L-2009-085
10 CFR 50.54(f)

Florida Power & Light Company
St. Lucie Unit 2
Docket No. 50-389

Subject: Response to NRC Request for Additional Information

**Individual Responses to NRC RAIs for FPL Generic Letter GL 2004-02
Supplemental Responses, Dated 02/27/2008 and 06/30/2008**

Figure 24-1: Head Loss Versus Time For PSL2

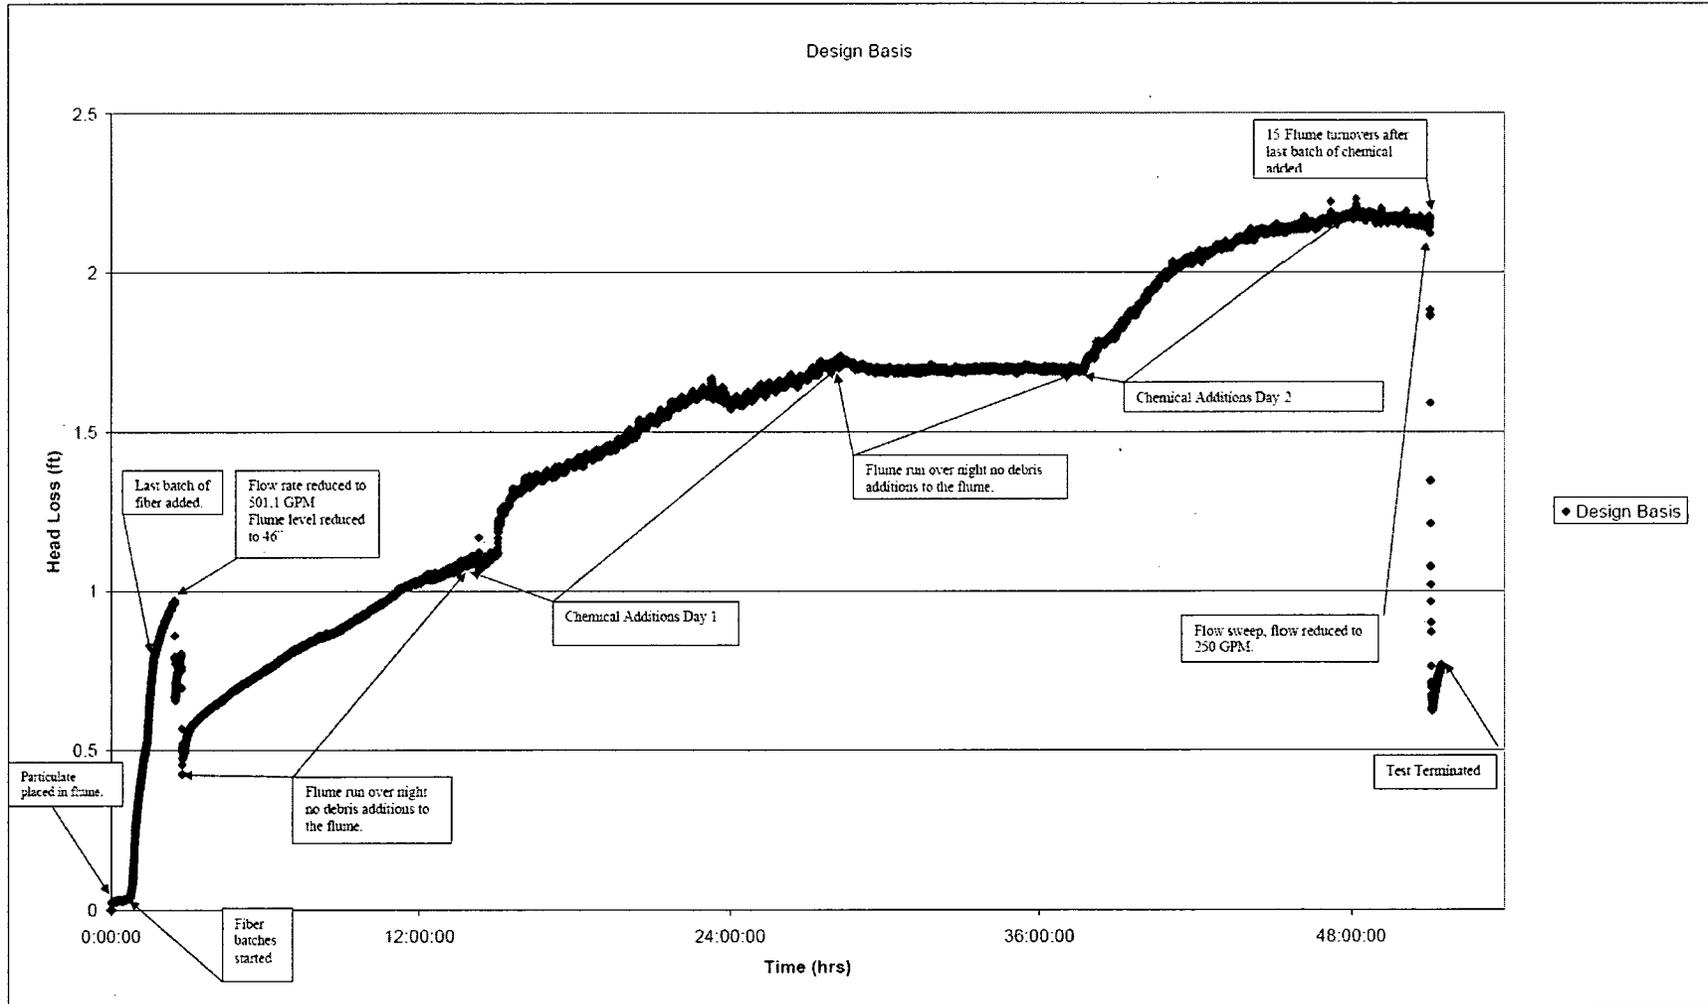
RAI-24: Provide a graph of the head loss testing for the duration of the chemical effects test including the non-chemical portions. Include information regarding events that would be expected to affected strainer debris bed head loss such as debris addition, large flow changes, etc.

RAI-24 RESPONSE: The head loss curve is presented below as Figure 24-1, the curve was developed with the raw data collected while testing and documented in the test plan.

Figure 35a-1: Head Loss Versus Time for PSL2

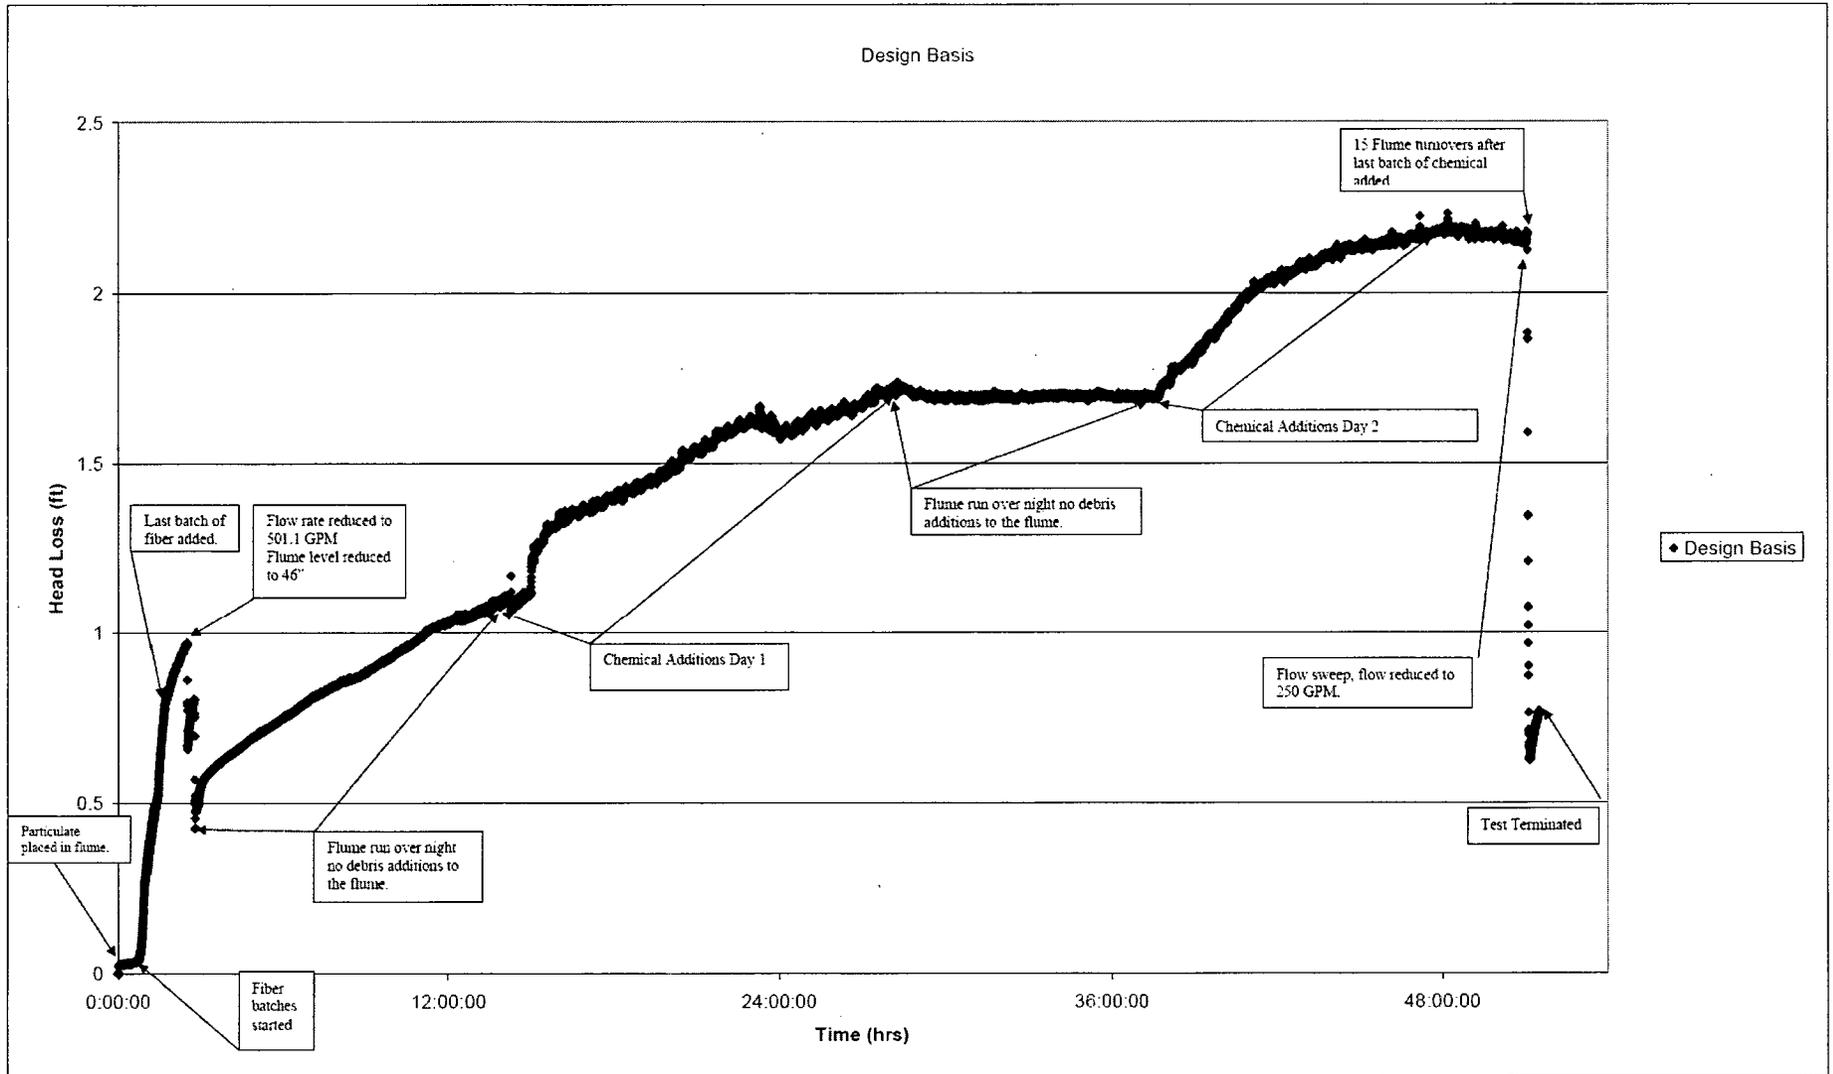
A Plot of the pressure drop as a function of time that also shows when debris and chemical precipitates were added to the test flume.

RAI-35a RESPONSE: A plot of head loss versus time was not completed while developing the St. Lucie Unit 2 Strainer Test. The graph presented below was developed for this RAI based on the raw data contained in the St. Lucie Unit 2 Strainer Test Plan. See Figure 35a-1, head loss versus time (test hours) plot below.
